HISTORIC AND DESIGN REVIEW COMMISSION

September 07, 2022

HDRC CASE NO: 2022-447
ADDRESS: 222 S ALAMO ST
LEGAL DESCRIPTION: NCB 13814 (HEMISFAIR - NORTHWEST QUADRANT), BLOCK 3
LOT 18
ZONING: D, H, RIO-3, Public Property
CITY COUNCIL DIST.: 1
DISTRICT: Hemisfair Historic District
APPLICANT: Chris Jaworski/HEMISFAIR PARK PUBLIC FACILITIES CORP
OWNER: Chris Jaworski/HEMISFAIR PARK PUBLIC FACILITIES CORP
TYPE OF WORK: Construction of a 17-story tower, mixed-use tower
APPLICATION RECEIVED: August 19, 2022
60-DAY REVIEW: Not applicable due to City Council Emergency Orders
CASE MANAGER: Edward Hall

REQUEST:

HEMISFAIR PARK AREA SITE PLAN

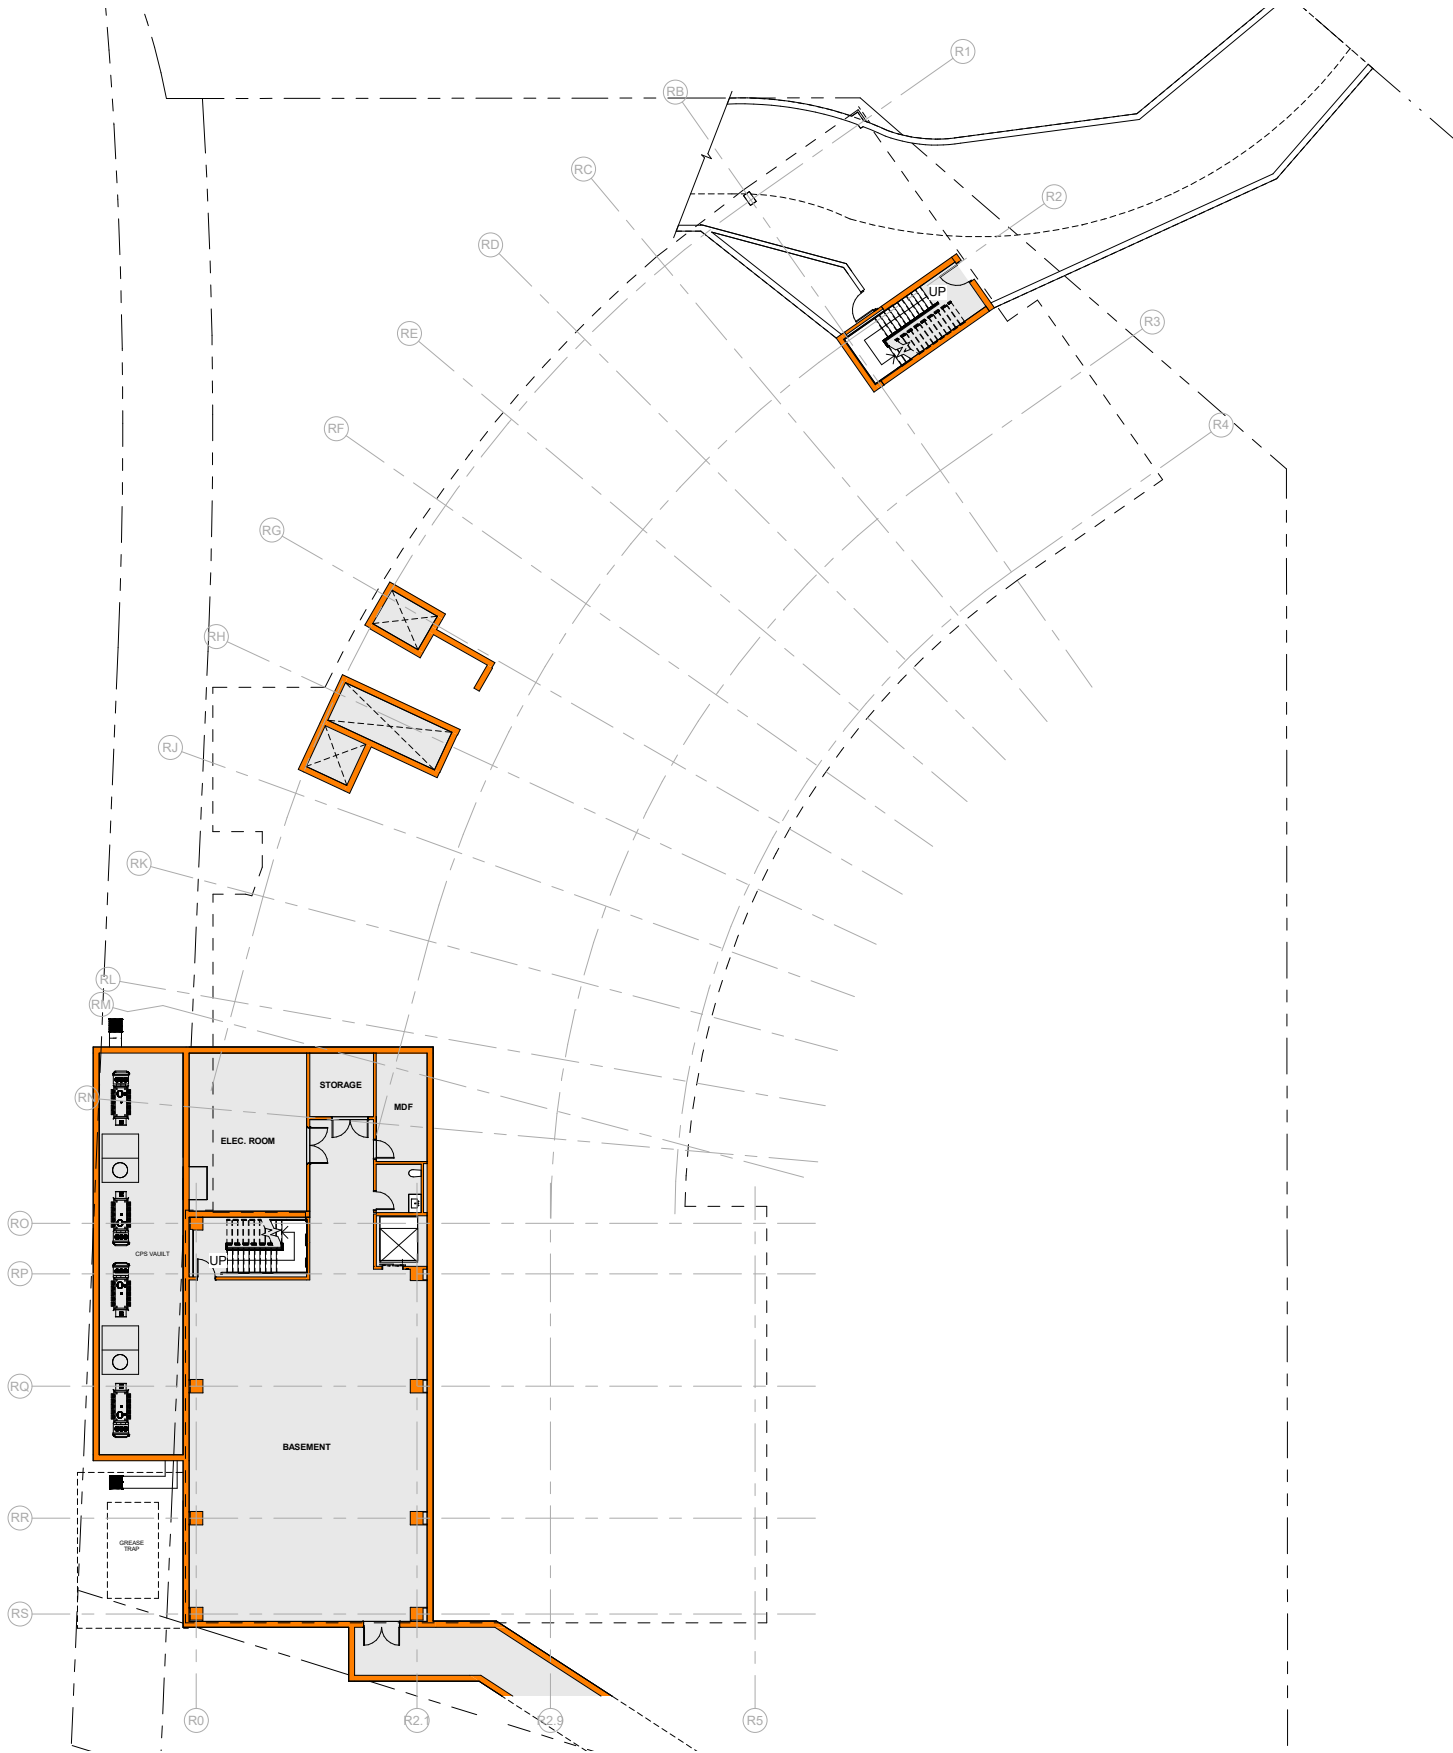
JF: Provide additional context to the site plan.
